**Community Development Department  
Plan Commission Staff Report  
February 16, 2012**

**Agenda Item F.3. Province Terrace Office Suites, 1427 Province Terrace, Parcel 7-00050-03**

Requested action: Revised Site and Landscape Plan Approval

PROPOSED LANDSCAPE PLAN

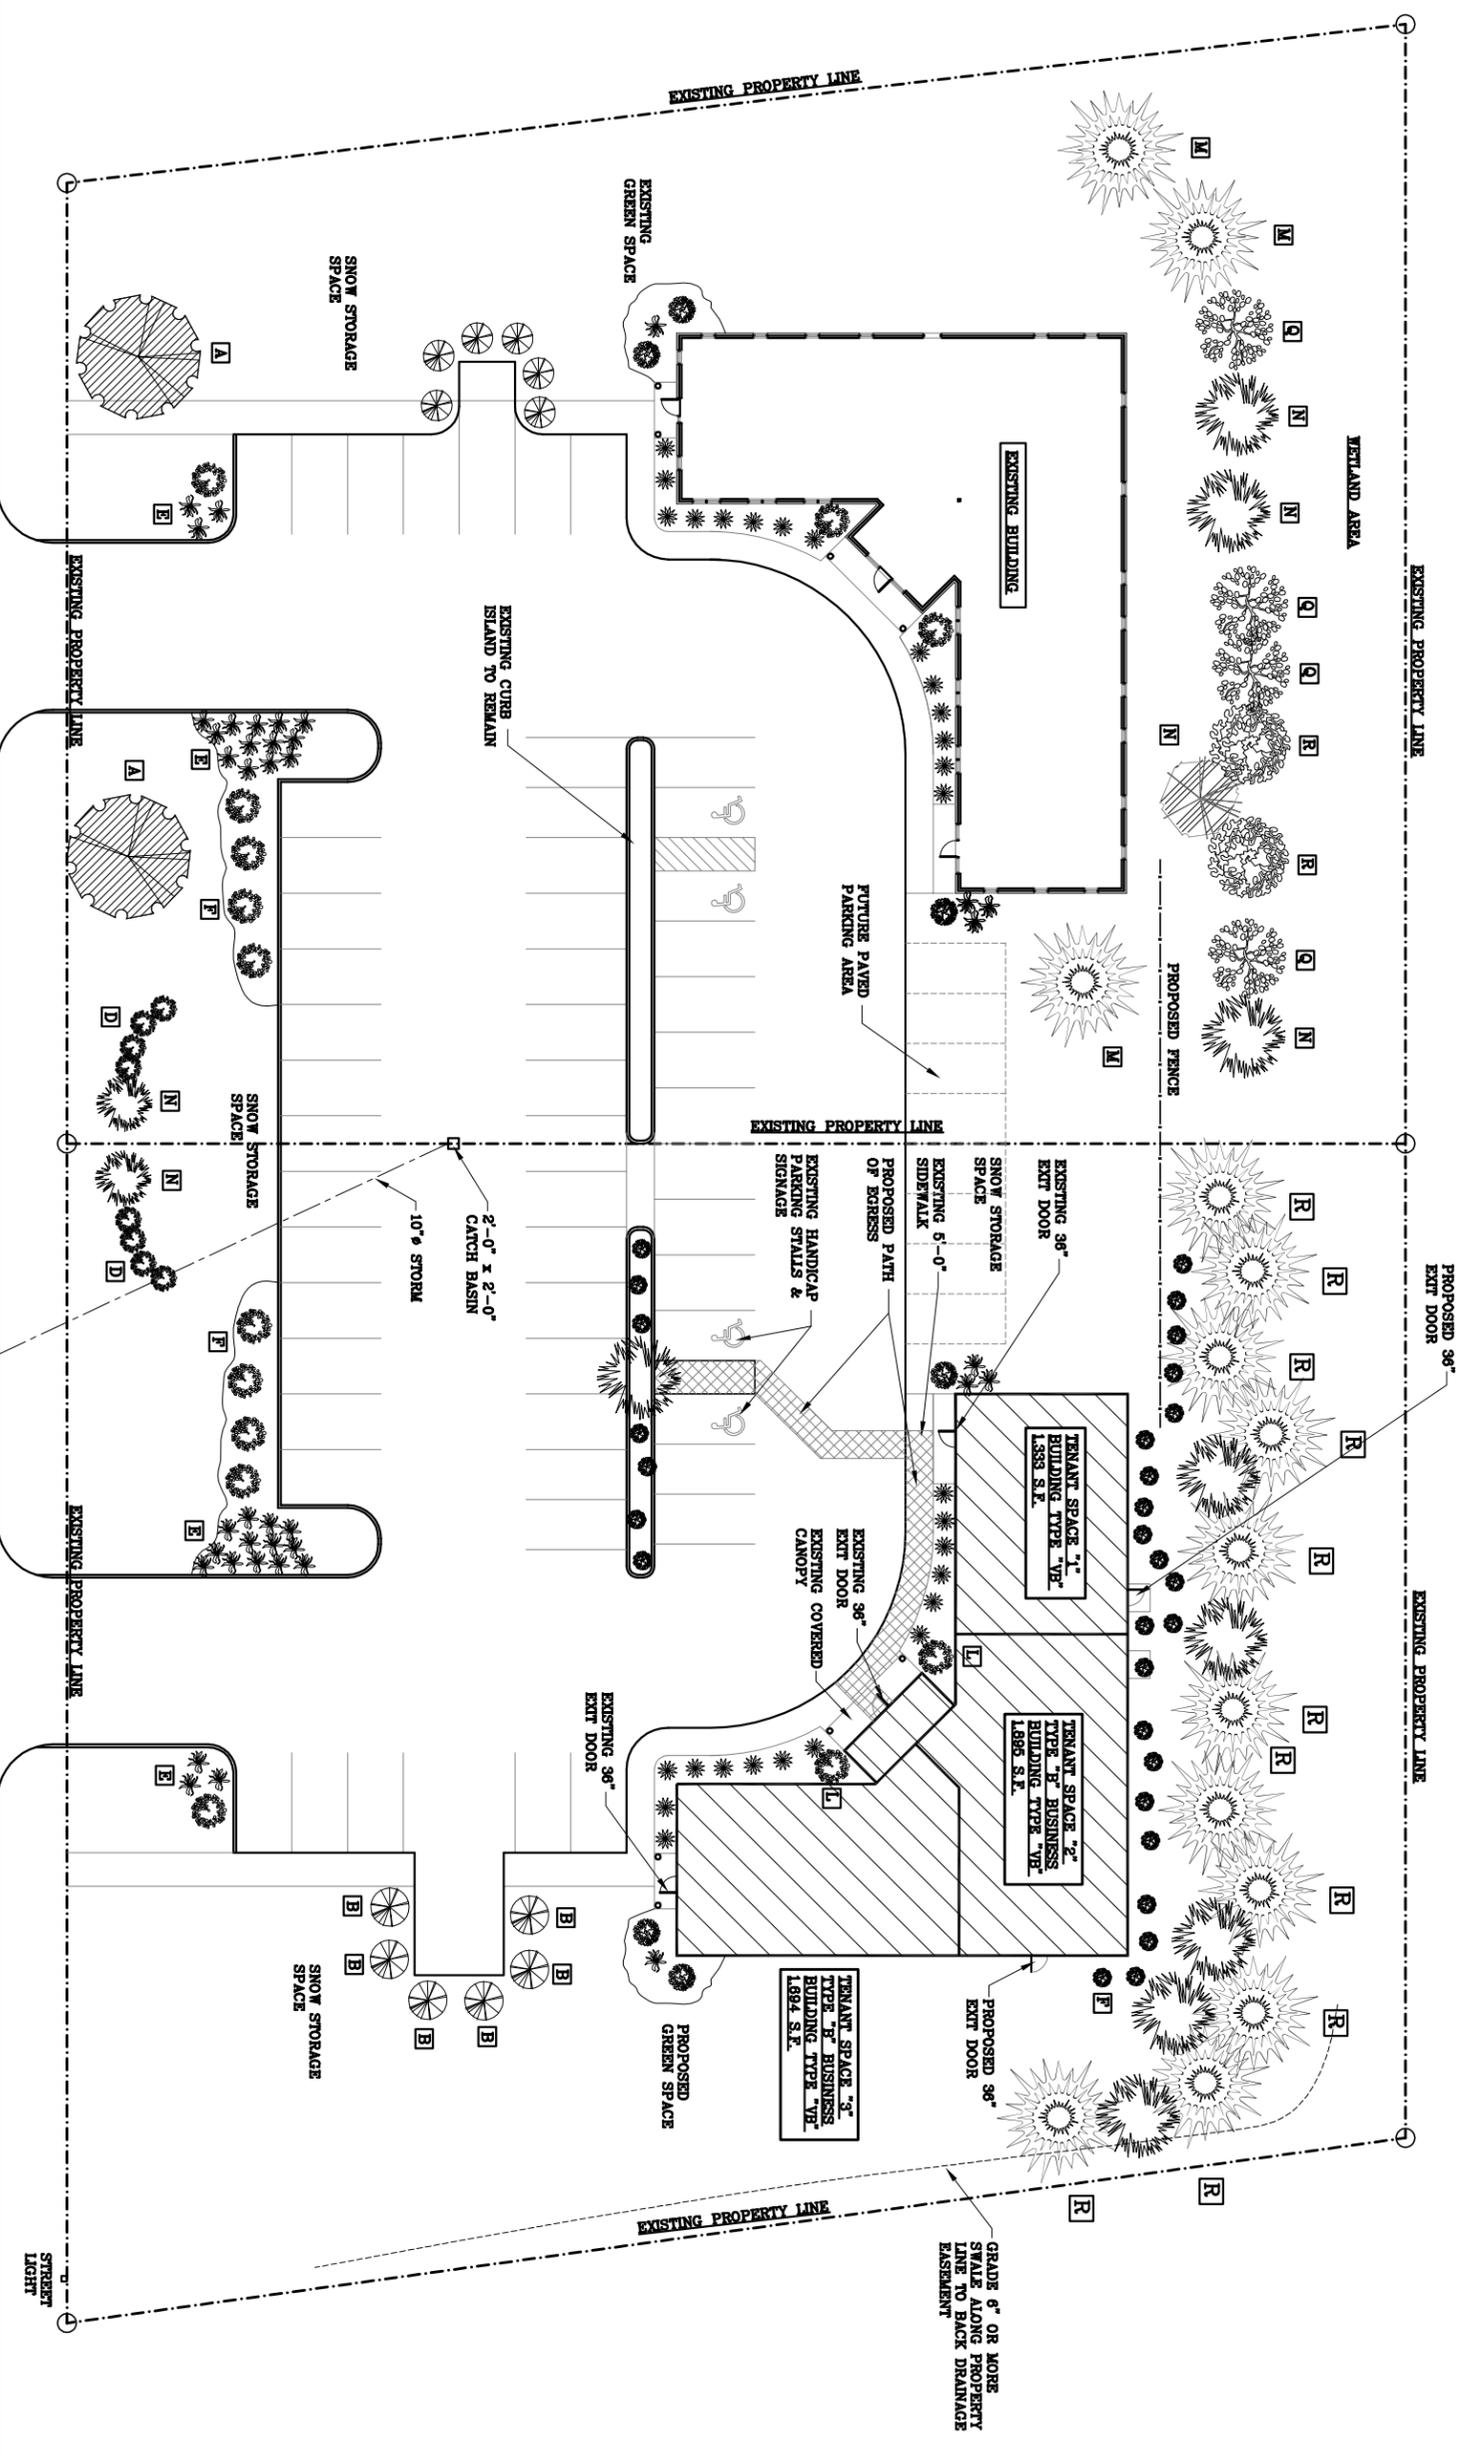
The C-3 District calls for the installation of 20% landscaping; the proposed plan appears to meet this requirement. Additional detail regarding specimen types and size is needed, especially for the transitional area and the parking lot landscaping.

As the property abuts R-1A to the East, a transitional landscaping buffer is required. The proposed landscape plan provides evergreen trees along with small shrubs along the foundation of the rear building façade, and a fence (to be constructed jointly with Salon Eternity) to screen the parking lot area and mitigate any light intrusion from parking lot traffic. A better mixture of

deciduous and evergreen, along with plant variety is needed to comply with the transitional area requirements. In addition, as the proposed transitional area utilizes fencing as part of the screening, Plan Commission must approve this as a suitable alternative for the site.

Staff's review of the parking lot landscaping (islands and perimeter), indicate that the proposed site plan is very close to complying with parking lot landscaping requirements. Two additional canopy trees are required between the parking Lot and Province terrace, along with more information on plant selection is required. In particular, shrubs for the parking lot perimeter screening must be at least 50% deciduous.

- Developer submits a lighting plan that is found acceptable by and approved by Community Development Staff, if not yet received and/or reviewed.
- Developer submits final design and materials for dumpster enclosure, which 75% opacity and be at least 6 feet in height.
- Developer submits a final landscaping plan to include the following:
  - Two additional deciduous canopy trees between the parking lot and Province Terrace
  - Revised planting scheme for the transitional area, to include a mix of deciduous and evergreen trees, and a greater variety of planting materials.
  - Parking Lot perimeter landscaping shrubs contain at least 50% evergreen.
  - Labeling of all planting materials, including proposed size and type.
